Access Compliance Report

Public Rights-of-Way

Intersection ID: 26934	Main Street: HADDONSHIRE_LN	Cross Street: LADY_GRACE_LN	Location: NE
ADA ID: B72F44A1DBF4	Ramp Type: Perp	Initial Pass/Fail: Fail	Overall Compliance: No
			Severity Score: 13.75

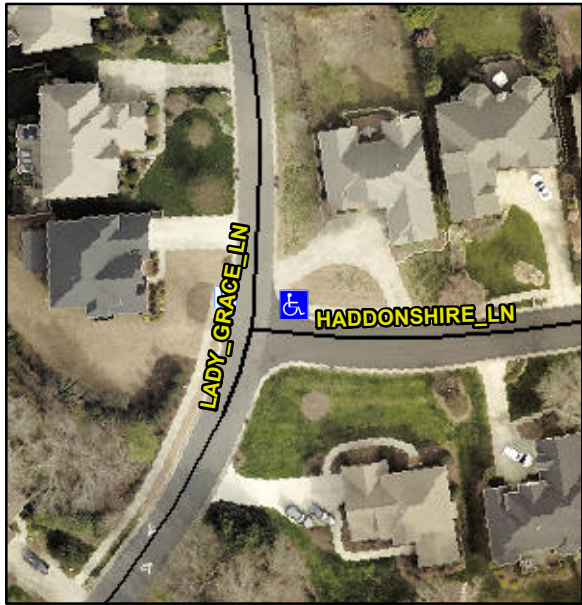
Codes/Mitigation Info/Possible Solution			Field Measurements/Component Compliance					
	Possible Solutions:		Remove & Replace Entire Ramp.					
	Surveyor Notes:		N/A					
	PROW/ADA:		Not Found, R304.2.2, R304.5.3					
	Street 1 Name		LADY GRACE LN					
	Stop Condition-Street 2		None					
	Street 2 Name		N/A					
	Stop Condition-Street 1		N/A					
	Total Cost:		\$ 1850.00					
			Compliance	Description	Data	Compliance	Description	Data
			N/A	Ramp Length (in)	73.0	No	Ramp Slope (%)	10.2
			Yes	Ramp Width (in)	48.0	No	Ramp XSlope (%)	4.1
			N/A	Flare Type LT	N/A	N/A	Flare Type RT	N/A
			N/A	Flare Slope LT (%)	N/A	N/A	Flare Slope RT (%)	N/A
			N/A	Flare Traversable LT?	N/A	N/A	Flare Traversable RT?	N/A
			N/A	Landing Length (in)	N/A	N/A	DWS Provided?	N/A
			N/A	Landing Width (in)	N/A	N/A	DWS Contrast?	N/A
			N/A	Landing Slope (%)	N/A	N/A	DWS Length (in)	N/A
			N/A	Landing X Slope (%)	N/A	N/A	DWS Full Width?	N/A
